Proposed design changes following consultation:

Proposed design changes following consultation:

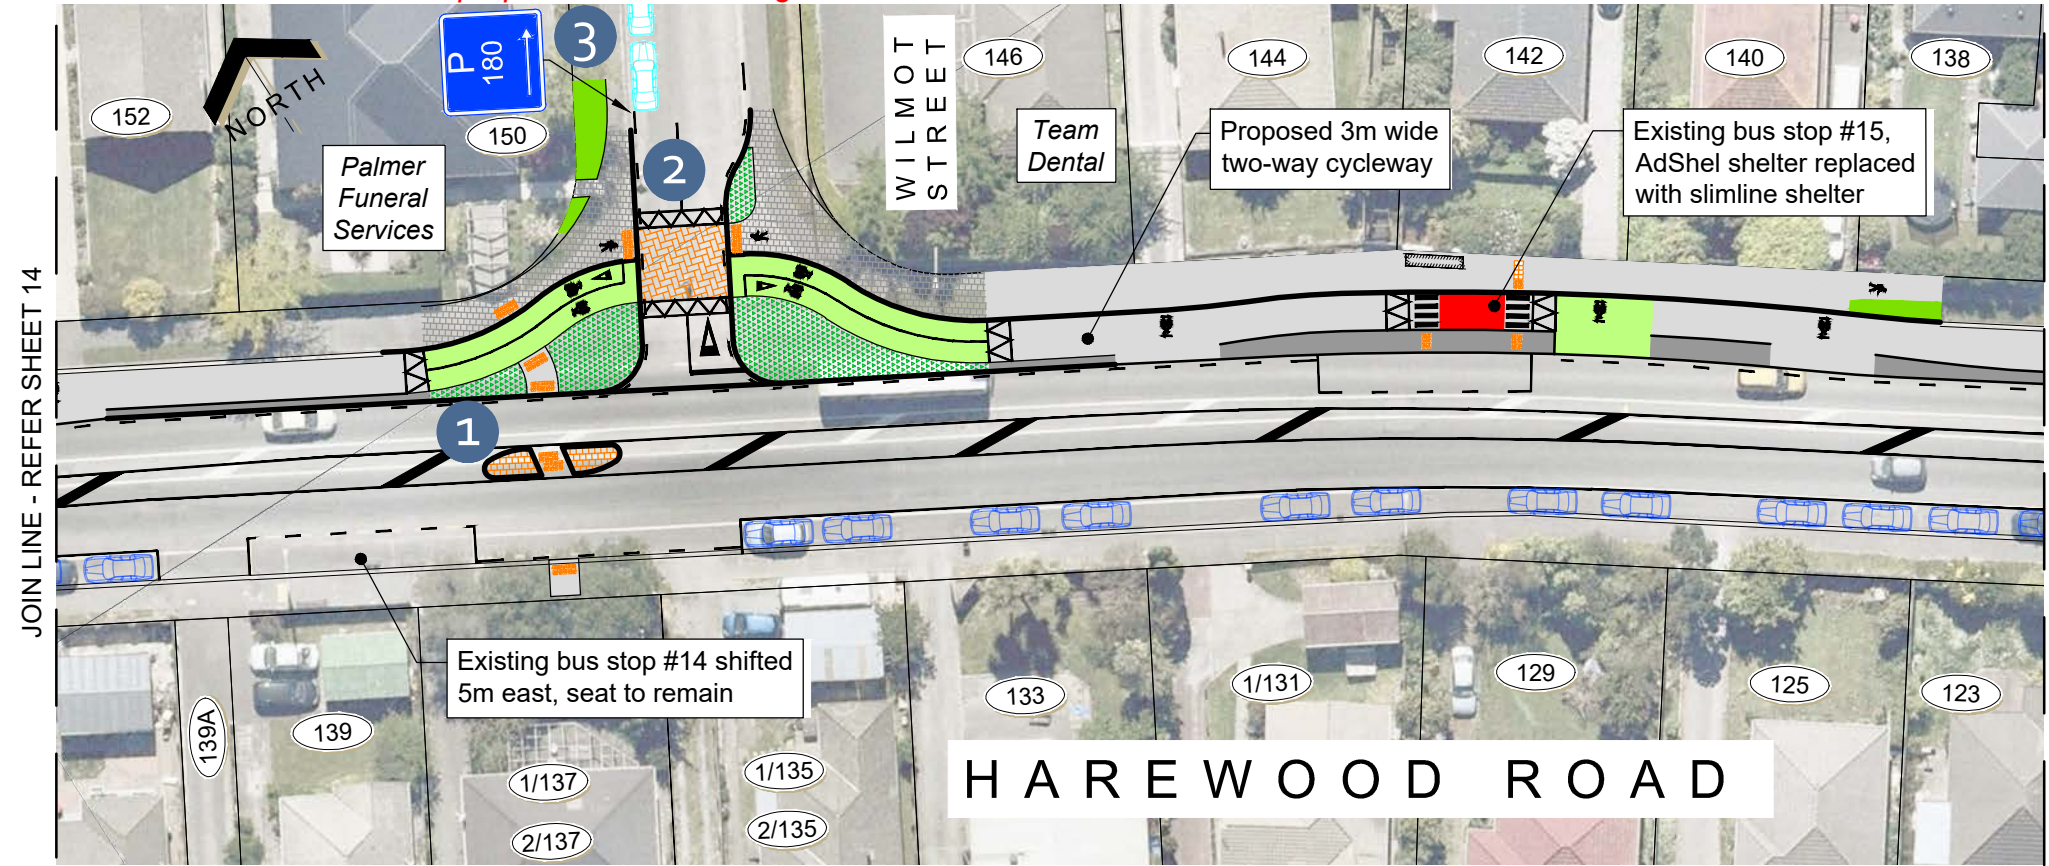
- Proposed design changes following consultation:**
- 1 An additional on-street parking space is provided on Harewood Road outside the Featherstone Dairy. This is designated P5.
 - 2 Two additional on-street parking spaces are provided on Harris Crescent (west), one on each side of the road.
 - 3 On the western side of Harris Crescent (west) at Harewood Road, two spaces are designated P10. On the eastern side, the length between Harewood Road and the first driveway is designated P10.
 - 4 Two P5 (Monday to Friday) spaces are designated outside the Harewood Road Medical Centre.

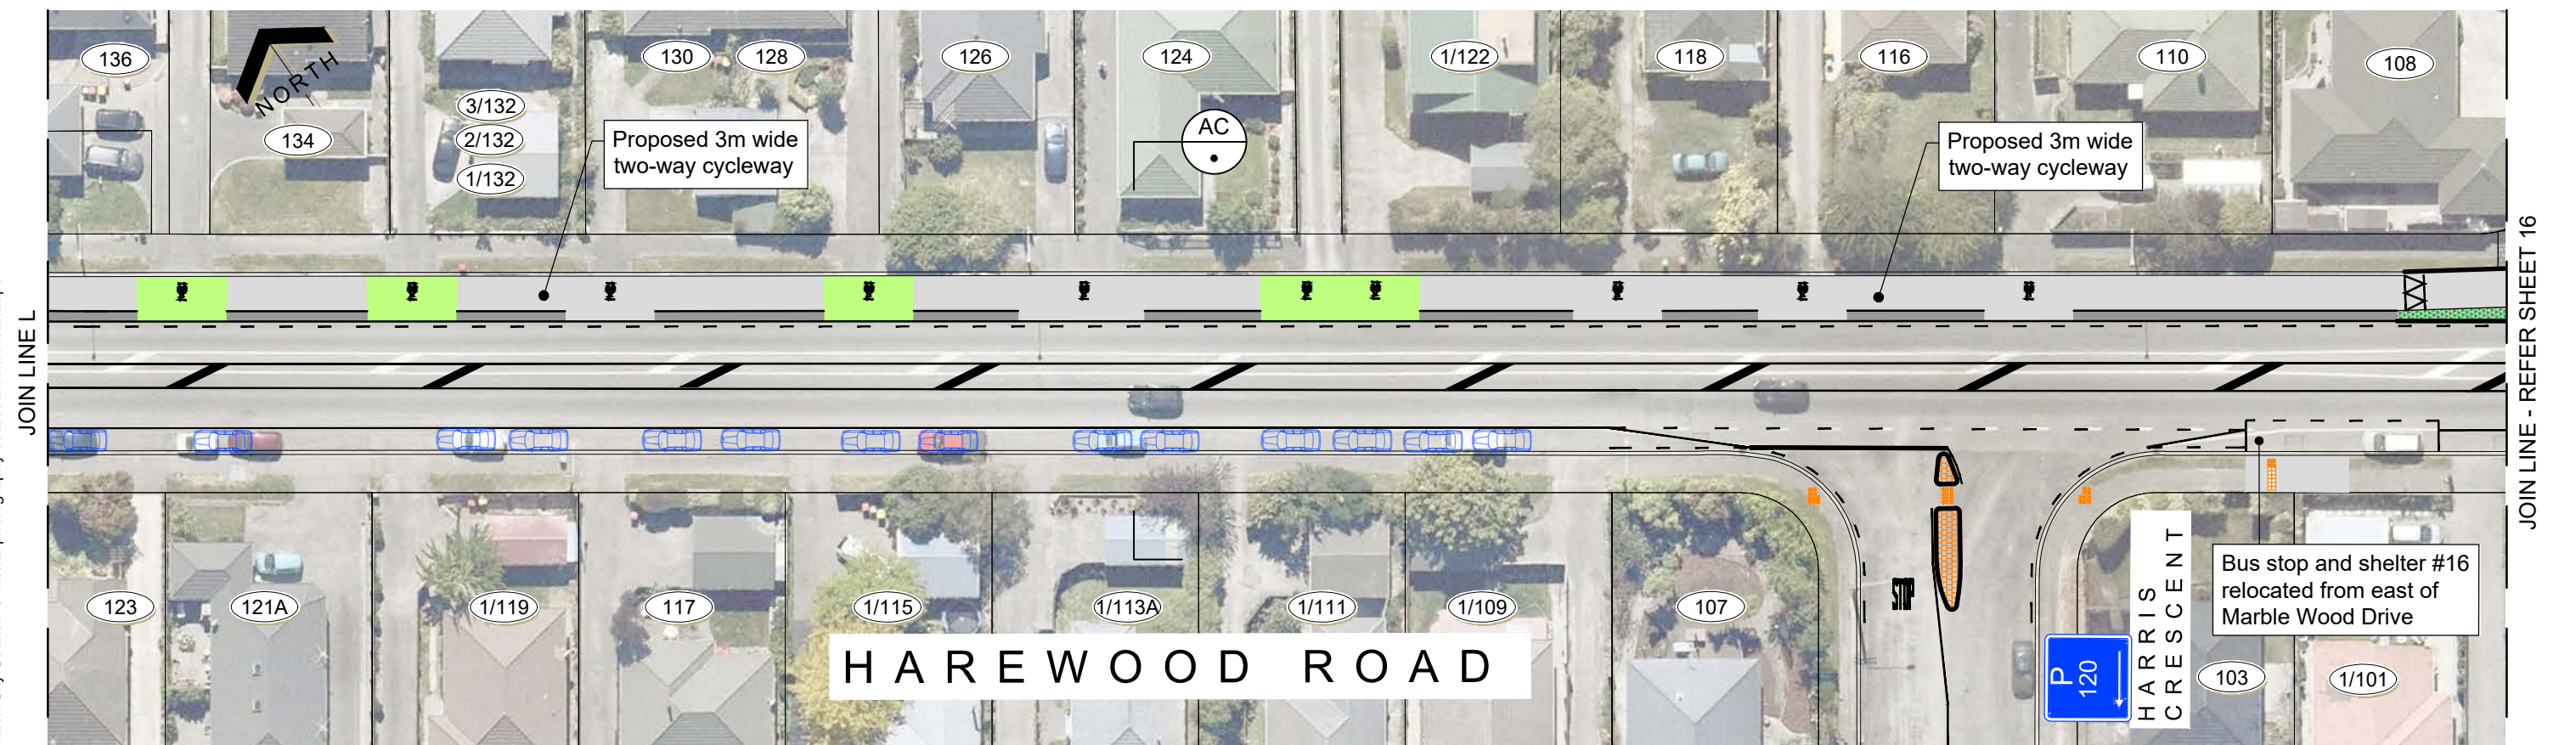
- Proposed design changes following consultation:**
- 1 A pedestrian refuge island is added on Harewood Road near Wilmot Street. A portion of cycleway is narrowed to fit the pedestrian island.
 - 2 The proposed cul-de-sac at Wilmot Street is shifted to the intersection with Hoani Street. This provides two additional on-street parking spaces on Wilmot Street outside Palmer Funeral Services.
 - 3 The proposed P120 parking restrictions on Wilmot Street are changed to P180.

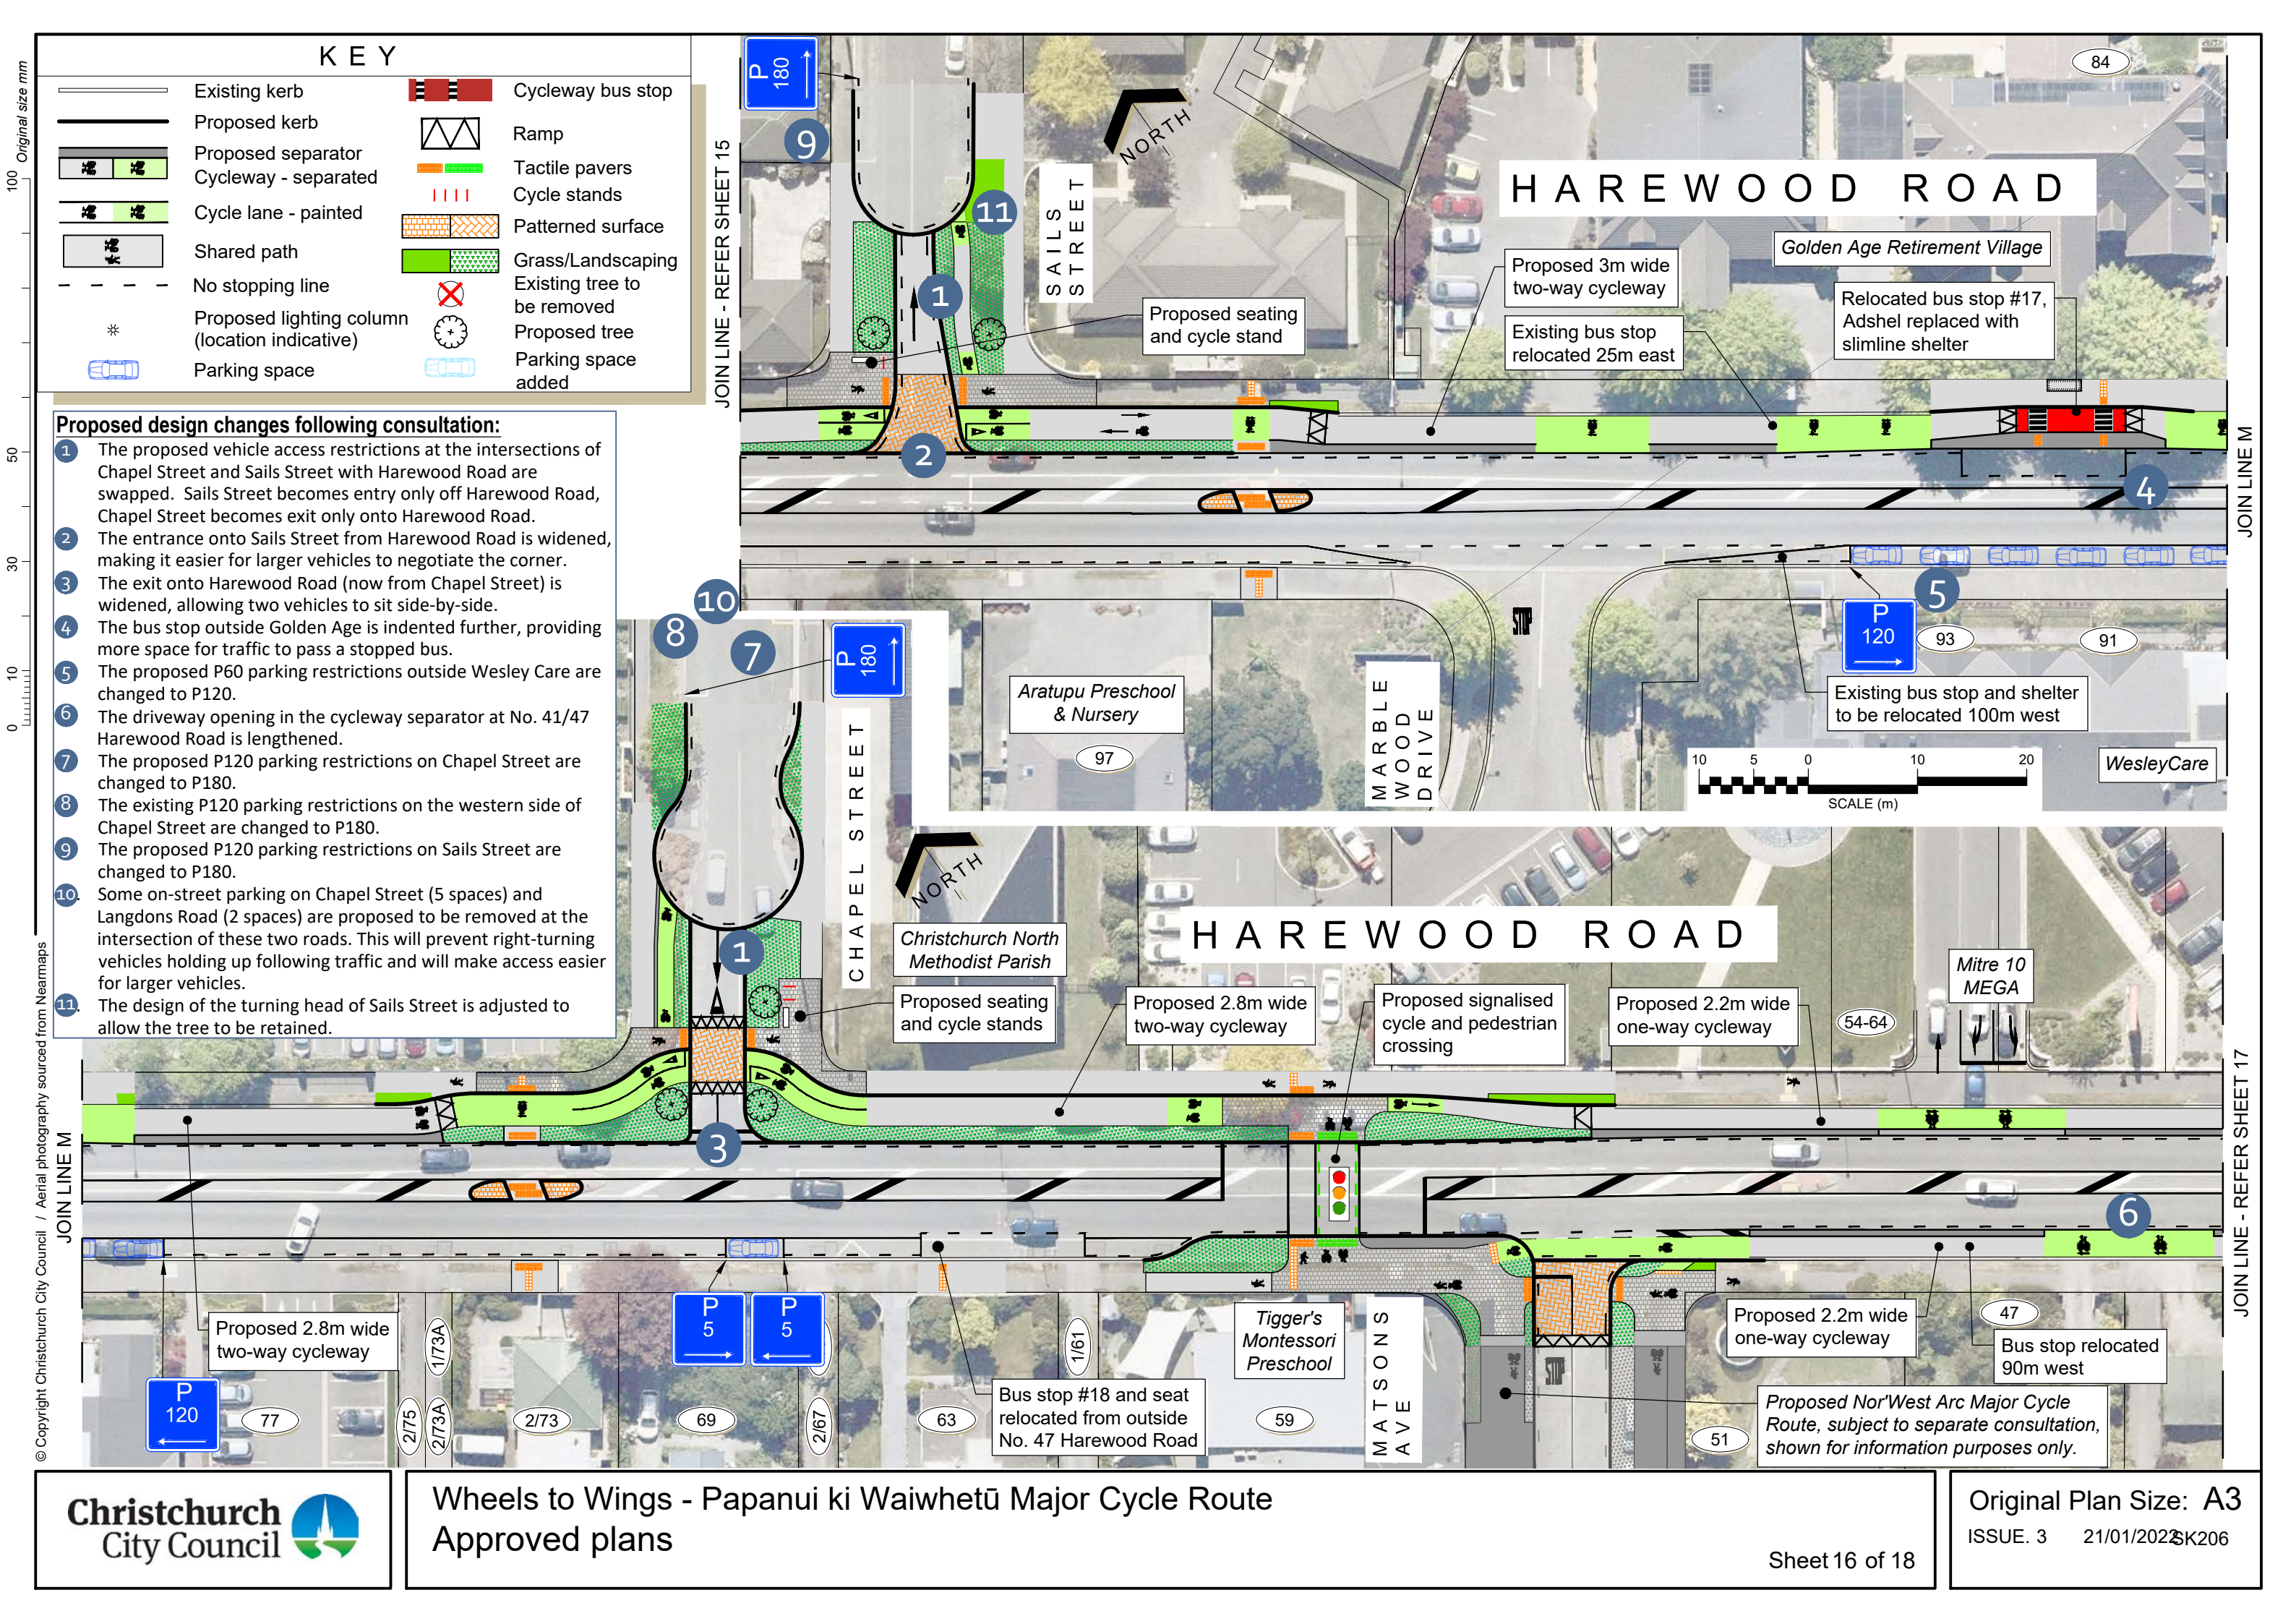
- 1 The proposed vehicle access restrictions at the intersections of Chapel Street and Sails Street with Harewood Road are swapped. Sails Street becomes entry only off Harewood Road, Chapel Street becomes exit only onto Harewood Road.

- 2 The entrance onto Sails Street from Harewood Road is widened, making it easier for larger vehicles to negotiate the corner.
- 3 The exit onto Harewood Road (now from Chapel Street) is widened, allowing two vehicles to sit side-by-side.

- 4 The bus stop outside Golden Age is indented further, providing more space for traffic to pass a stopped bus.
- 5 The proposed P60 parking restrictions outside Wesley Care are changed to P120.

- 6 The driveway opening in the cycleway separator at No. 41/47 Harewood Road is lengthened.
- 7 The proposed P120 parking restrictions on Chapel Street are changed to P180.

- 8 The existing P120 parking restrictions on the western side of Chapel Street are changed to P180.
- 9 The proposed P120 parking restrictions on Sails Street are changed to P180.

- 10 Some on-street parking on Chapel Street (5 spaces) and Langdons Road (2 spaces) are proposed to be removed at the intersection of these two roads. This will prevent right-turning vehicles holding up following traffic and will make access easier for larger vehicles.

- 11 The design of the turning head of Sails Street is adjusted to allow the tree to be retained.

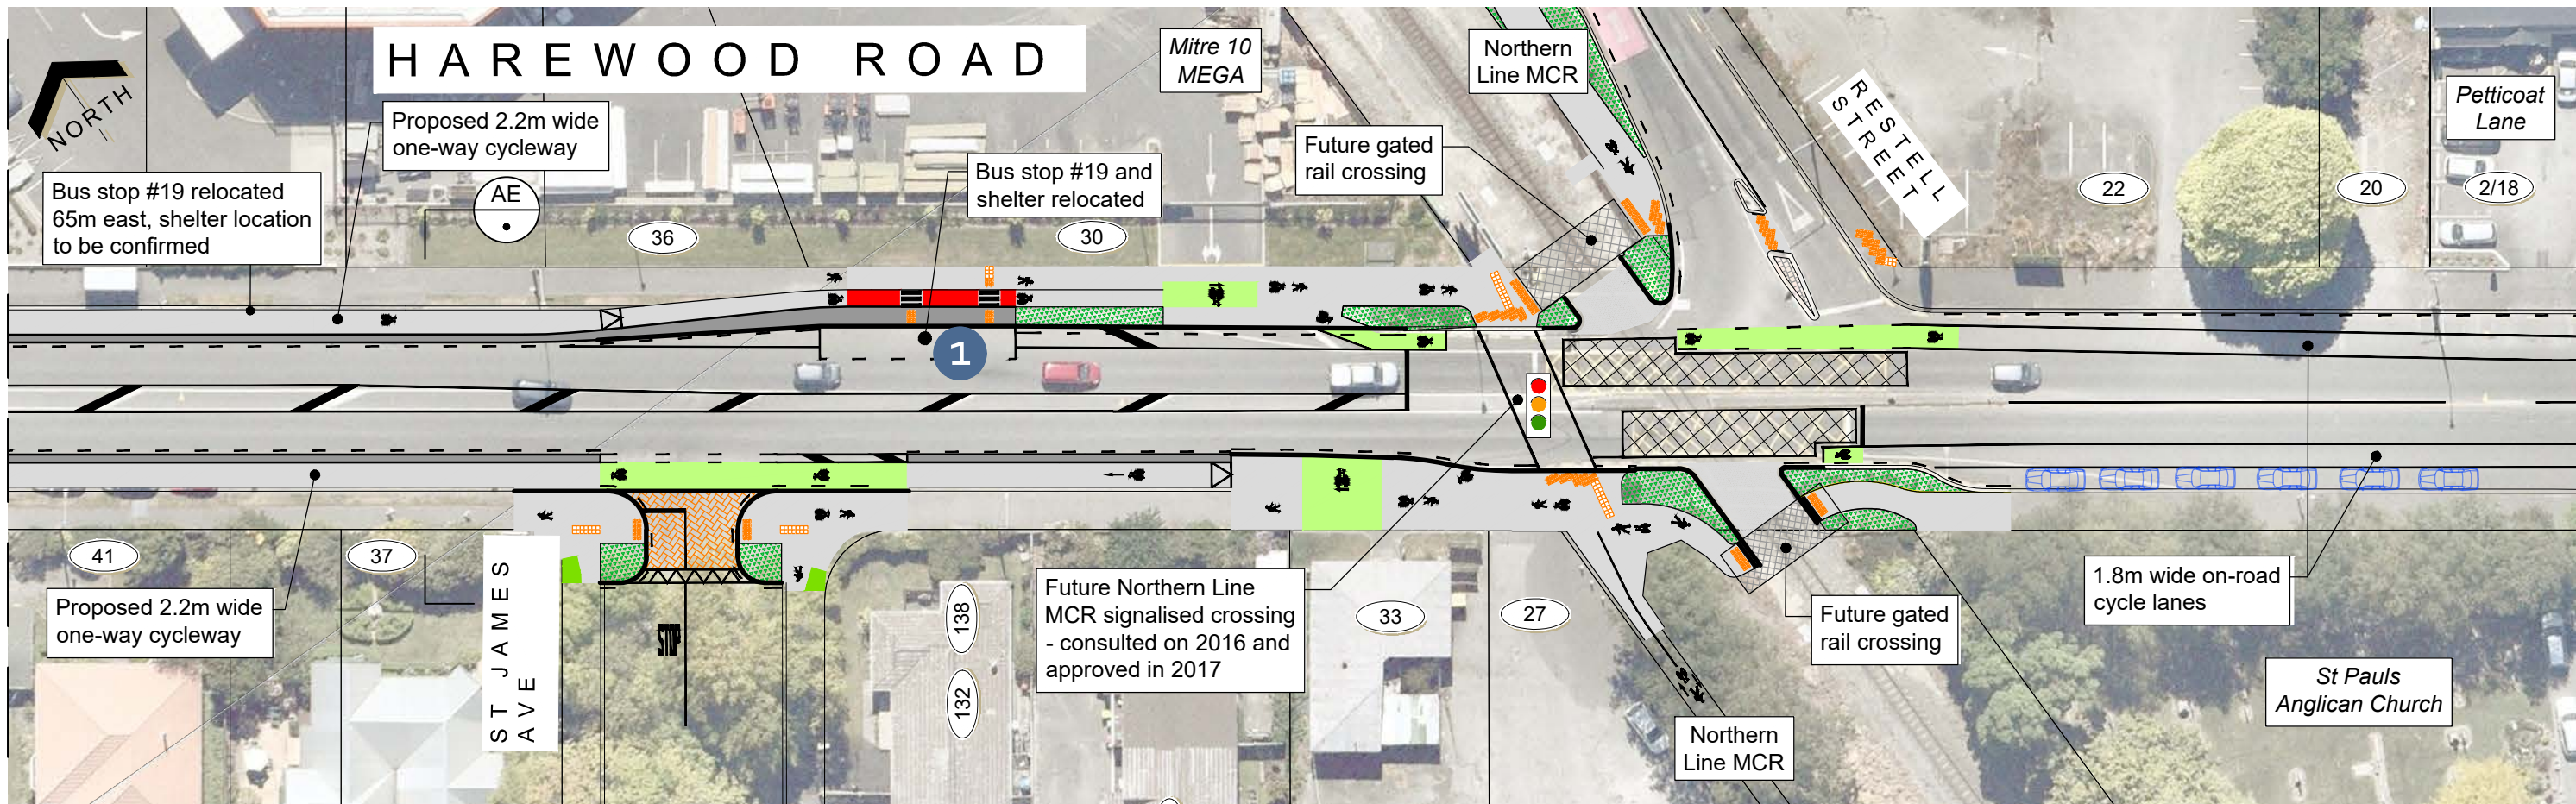
- 1 The eastbound bus stop outside Mitre 10 is indented and shifted to 65 m east of its existing location.
- 2 Additional cycle markings are added approaching Main North Road.
